From: Henry Dong
Sent: Wednesday, March 15, 2023 8:14 AM
To: David Sablan; codewordconsulting@gmail.com; Deirdre McCartney; Allen Tai
Subject: FW: [EXTERNAL] RE: Invitation to Provide Comments to Planning Board on Objective Design Review Standards

Subject: Revised draft objective design review standards (Item 7-B on Planning Board's 2-22-21 agenda) –Preliminary AAPS comments.

Subject: Revised draft objective design review standards (Item 7-B on Planning Board’s 2-22-21 agenda) –Supplemental AAPS comments.

2/22/21 ADOPTED OBJECTIVE DESIGN REVIEW STANDARDS

FIGURE 1:

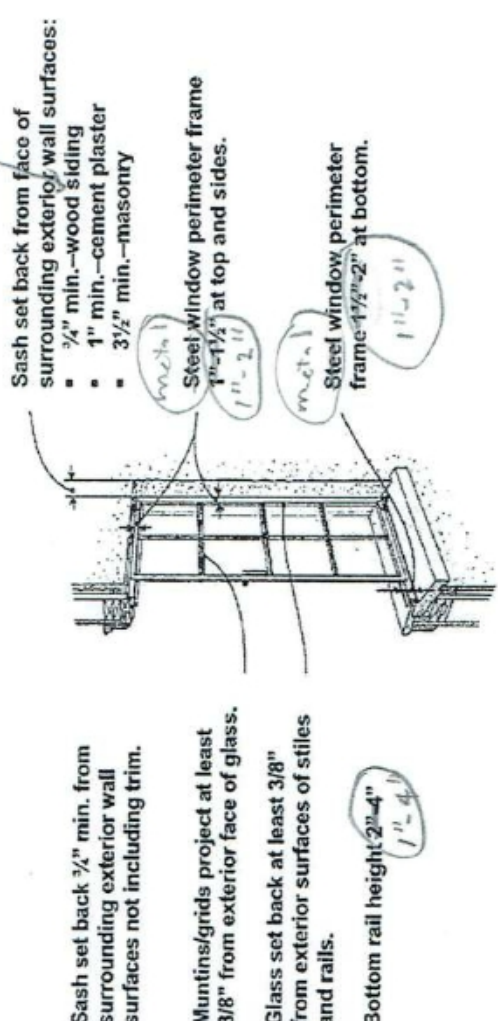
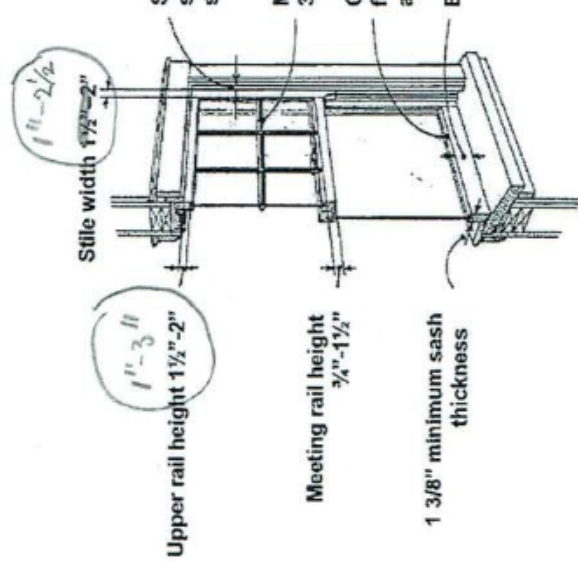
Window dimensions shall correspond to the typical dimensions of wood or (if consistent with the reference building's architectural style or the context buildings) metal as shown on Figure 1.

Individual windows within groups shall be separated by vertical trim or wall surfaces at least 6" wide
